INDESIT company

Model type:
AT50EX

Commercial code:
F027204

FIG. 1

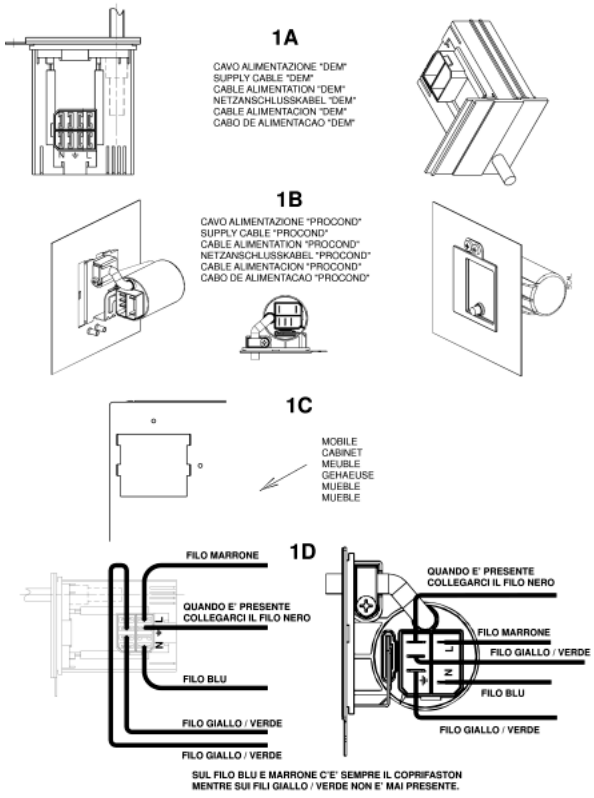
From serial number 30224.0001, all top-load washing machines produced in the Brembate factory have been equipped with a new power supply cable with moulded filter and new rear panels with a specific opening for fixing the new cable.

To use premodified wirings on modified products perform the connection to the terminal block of the new cable as shown in fig. 1 - 1D.
The wiring diagrams indicated in the Documentation remain the same.

N1040309FIG1

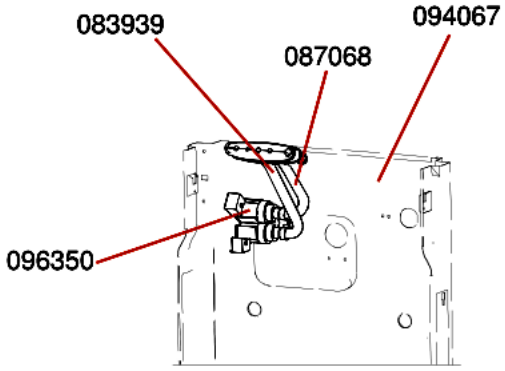
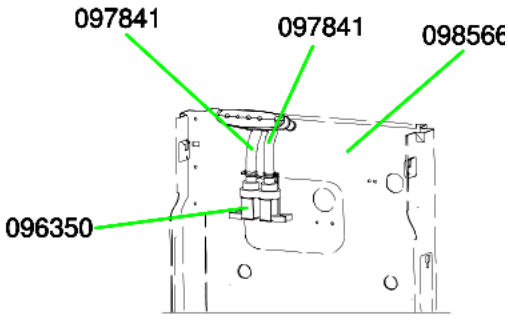
From serial no. 30912.0001, the system used for fixing the loading solenoid valve (spare part code 096350) to the rear panel has been modified on Top Loading washing machines, rotating its position by 90°.
The solenoid valve (spare part code 096350) has been modified with the 45° rotation of a coil; the Replacements Warehouse will continue to manage this part with the same code. When replacing on premodification machines, fit the coils as shown in figure N1040309FIG3-1 and on modified machines, as shown in figure N1040309FIG3-2; to rotate the coil, lift it using a screwdriver and then refit according to the inserts on the plastic.

Replacement codes of the parts affected by this modification (see figure N1040309FIG1):

FIG1 A - PREMODIFICATION STRUCTURE
solenoid valve tube/distributor assembly: premodification 083939;

solenoid valve tube/distributor assembly: premodification 087068;
rear panel: premodification 094067.
FIG1 B - NEW STRUCTURE
solenoid valve tube/distributor assembly: new 097841;
solenoid valve tube/distributor assembly: new 097841;
rear panel: new 098566.

Premodification panels will be managed by the Replacements Warehouse while stocks last; when replacing with new ones on premodification appliances the new tubes must also also be used.
When using the new panels on appliances before serial no. 30609.0001, fitted with solenoid valve code 083940, rotate the coil 45° and follow the instructions given above for code 096350, paying attention during the wiring phase to keep the cables away from the bowl support spring.

N1040309FIG2

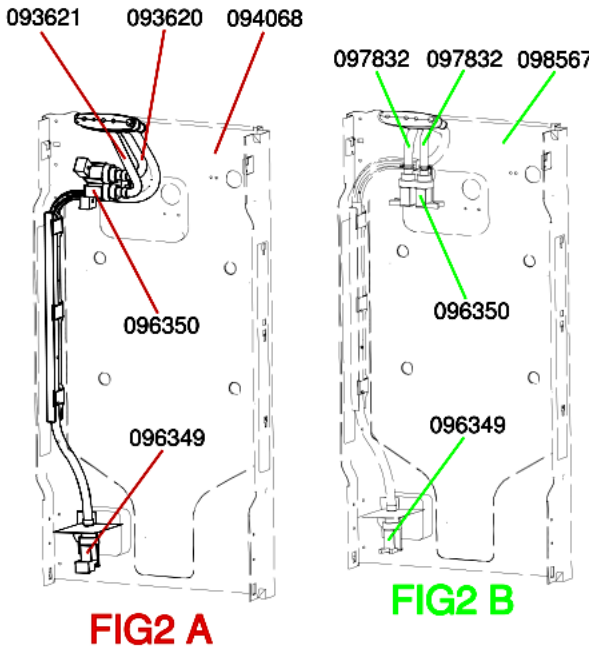
Replacement codes of the parts affected by the modification to WMTL80UK (see figure N1040309FIG2):

FIG2 A - PREMODIFICATION STRUCTURE
solenoid valve tube/distributor assembly: premodification 093620;
solenoid valve tube/distributor assembly: premodification 093621;
rear panel: premodification 094068.
FIG2 B - NEW STRUCTURE
solenoid valve tube/distributor assembly: new 097832;
solenoid valve tube/distributor assembly: new 097832;
rear panel: new 098567.

n1040321: Plastic protecion for solenoid valve.

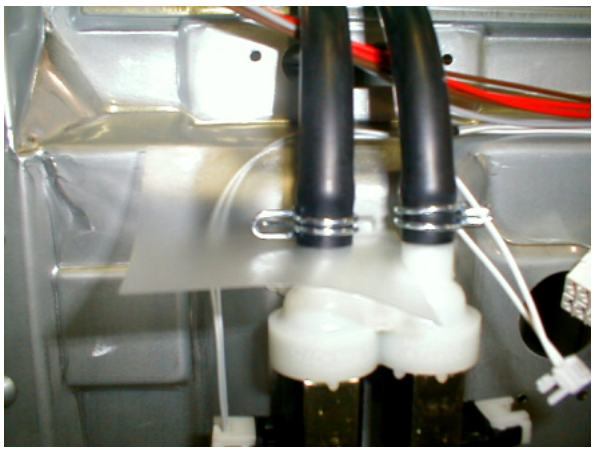
All top-load washing machines produced from September 2003 to February 2004 (from serial no. 30900.0000 to 40300.0000) have been equipped with a plastic protection Service code 109798 (shown in N1040321FIG1), to prevent water from damaging the solenoid valve and electronic card.

N1040324FIG1

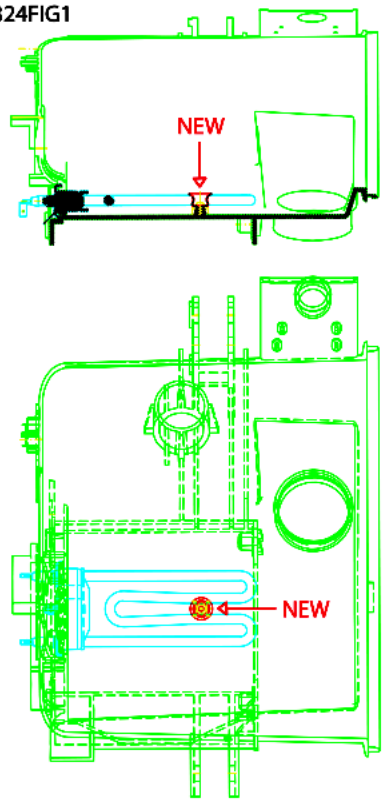
From serial number 40506.0001, the fixing system of the heater to the tank has been modified on all top-load washing machines affected by this note, with the introduction of a metal retainer (image N1040322FIG1 reference NEW) in place of deflector Service code 055322.

The modification has involved both heater and tanks. Given below are the Service codes of the new and old items concerned:

-PLASTIC TANK FOR 600-1000 RPM MACHINES: new 110152, premodification 083805;

-PLASTIC TANK FOR 1200 RPM MACHINES: new 110153, premodification 092023;

-HEATER: new 110148, premodification 083906.

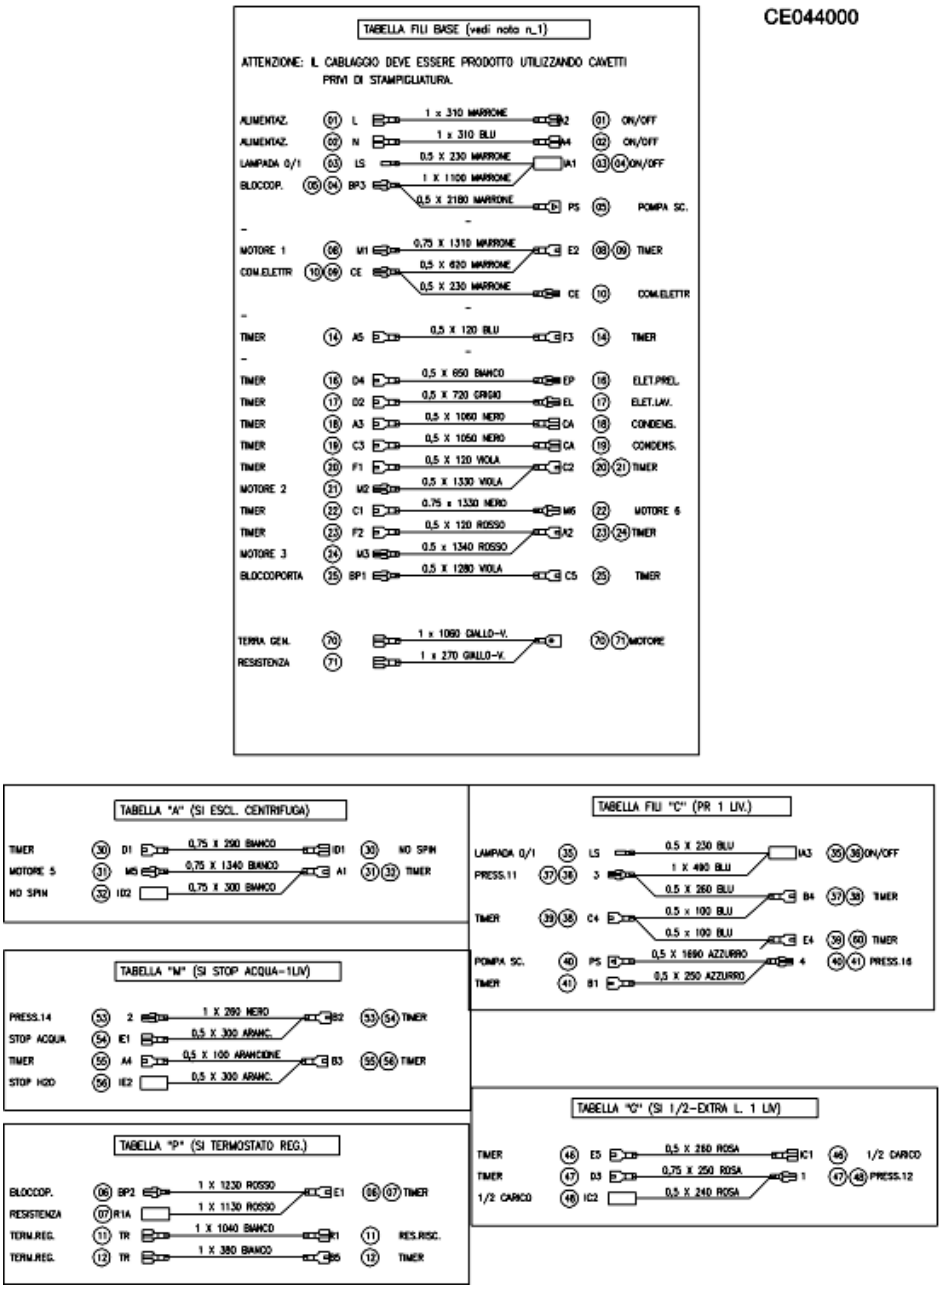
Top Loading washing machines have changed the fix of motor to the tub.
The tub design is changed in the motor fixing side and two new screws code C00268497 are introduced instead of the old screws C00084333 and the old nut:

In assistance on premodification products with the new tubs, you have to fix the motor using the new screws C00268497 instead of the screws and nut that you find in the product.
